Docket: : R.11-02-019
Exhibit Number : DRA-03
Commissioner : Florio
ALJ : Bushey
Witness : Roberts

**DIVISION OF RATEPAYER ADVOCATES
CALIFORNIA PUBLIC UTILITIES COMMISSION**

**Report on the
Pipeline Safety Enhancement Plan of
Pacific Gas and Electric Company**

R.11-02-019

1 Figure 13 – Results of PG&E QRA analysis for entire PSEP

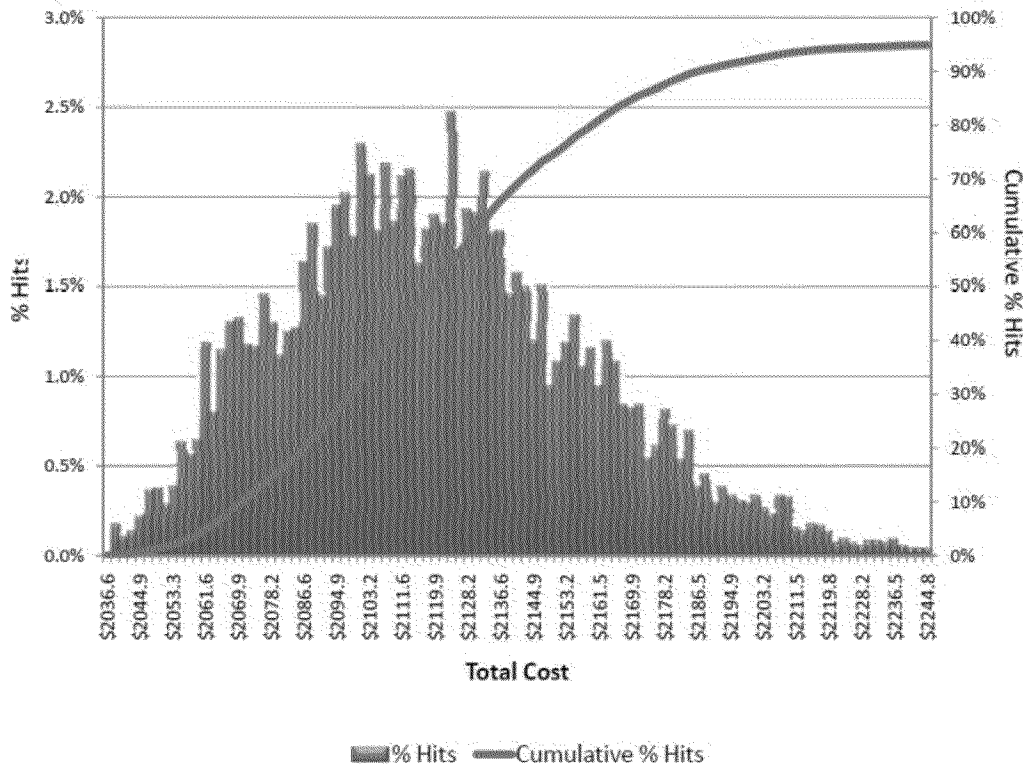
PG&E’s QRA analysis is best summarized by the “Cumulative % Hits”
versus “Total Cost” relationship shown on Figure 7-5 of PG&E’s Testimony:¹⁸⁸

1 Figure 7-5 would show that there would be a probability of greater than zero (P0)
2 that actual costs will be less than the 2,036.6 million PG&E shows in Figure 7-5.
3 If PG&E were to use the ACEI Classification Range (-30% to +50%) shown in
4 Table 7-6 for Class 4 estimate, it can be argued that the P0 values should be even
5 *less* than the baseline cost of \$1,803.4 million. Given that DRA's analysis shows
6 PG&E's baseline cost estimate to be higher than industry averages, the QRA
7 should show a significant probability that actual costs could be lower than the
8 baseline estimate. The histogram shown in Figure 7.5 does not show distribution
9 of outcomes for actual costs on either side of the base estimate as the ACEI
10 range for a Class 4 estimate would indicate. At a minimum, the QRA should show
11 a significant probability that actual costs could be less than PG&E's current
12 2,036.6 million estimate at P0. It appears as if PG&E tailored its assumptions for

13 the QRA model to obtain a pre-determined level of contingency for the PSEP
14 Pipeline Plan project, rather than using reasonable assumptions to let the QRA
15 model suggest a proper level of contingency.

1 Figure 15 – PSEP Contingency request for pipeline replacement compared to
 2 PG&E QRA results¹⁹¹

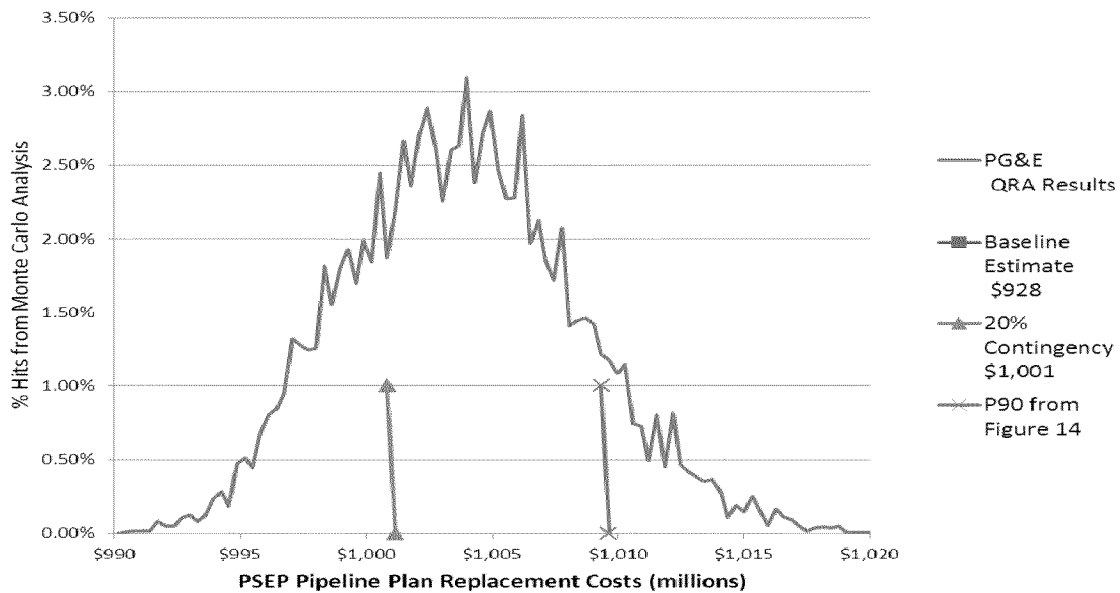
5 Figure 15 illustrates that PG&E’s QRA provides outcomes roughly
 6 centered on the 20% value chosen by PG&E, but skewed to the right (greater
 7 probability of higher cost). This figure also illustrates the discrepancy mentioned
 8 in footnote XXX of this exhibit, since PG&E’s 20% contingency is supposed to be
 9 a P90 value. It is clear from this figure that the 20% contingency is not a P90
 10 value.
